SNUPPS

Standardized Nuclear Unit
Power Plant System

September 1, 1981

SLNRC 81-82 FILE: 0541
SUBJ: ICSB Review

Figure 2

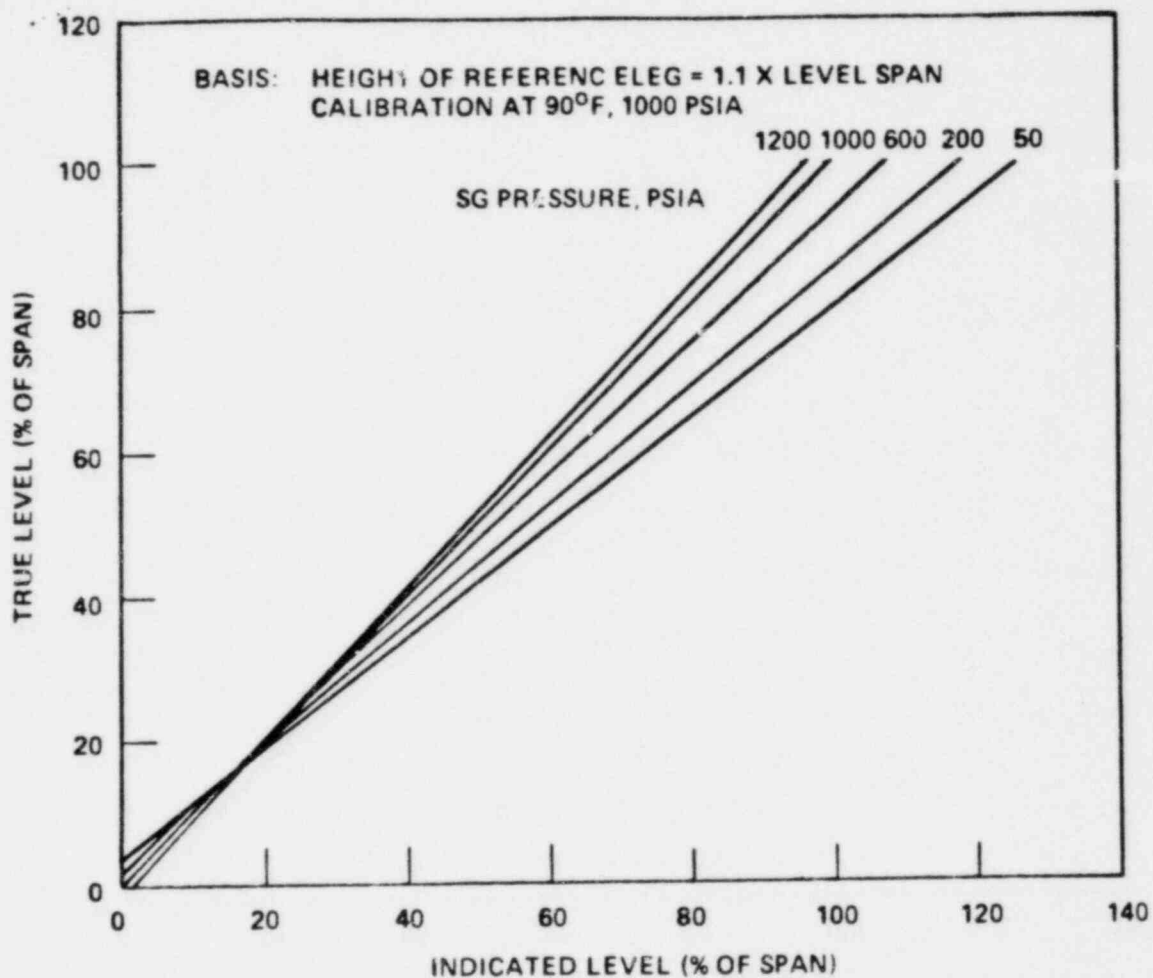
For an example, Figure 2 shows the true water level as a function of steam generator pressure and indicated level, assuming the following calibration conditions: Containment temperature = 90°F, steam generator pressure = 1000 psia, and the reference leg is at 90°F. Figure 3 is similarly calculated for a pressurizer, with the assumptions noted on the Figure.
